## **Amendments to the Drawings**

Applicant respectfully requests acceptance of the following changes to the drawings shown in the attached marked up pages 1, 2 and 3. These changes are incorporated in the two (2) pages of formal drawings submitted herewith.

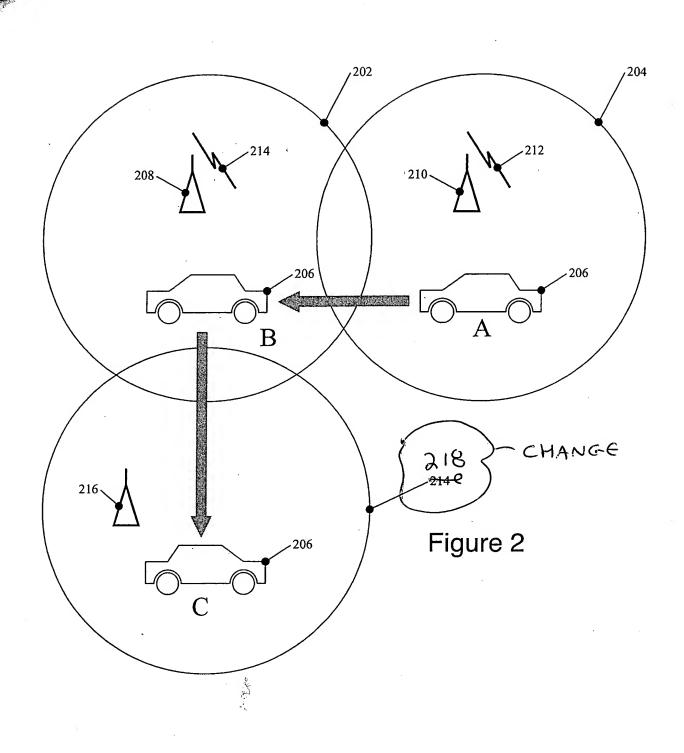
1. Amend Figure 1 block 10 as follows, this change is supported in paragraph [007] of the original specification, which states that "In step 110, the service provider then terminates the call by releasing the allocated communication channel":

Block 10 caption: End of Service Provider terminates OTA call

- 2. Amend Figure 1 by add "PRIOR ART" to the caption.
- 3. Amend Figure 2 by correcting the reference designator from "214" to --218-- as supported in paragraph [020] of the original specification.
- 4. Amend Figure 3 blocks 306 and 308 as follows, these changes are supported in paragraph [022] or the original specification, which states that "Once all OTA messages are exchanged, and the OTA session has ended, the **mobile subscriber unit** can be configured to detect the end of the OTA session in step 306. The **mobile subscriber unit** can be configured to then release the OTA call in step 308, once the end of the OTA session is detected in step 306." (emphasis added)

Figure 3

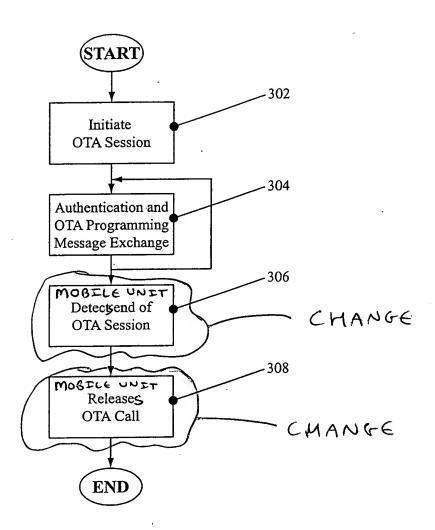
Block 306 caption: Detect Mobile Unit detects end of OTA Session

Block 308 caption: Release Mobile Unit releases OTA Call
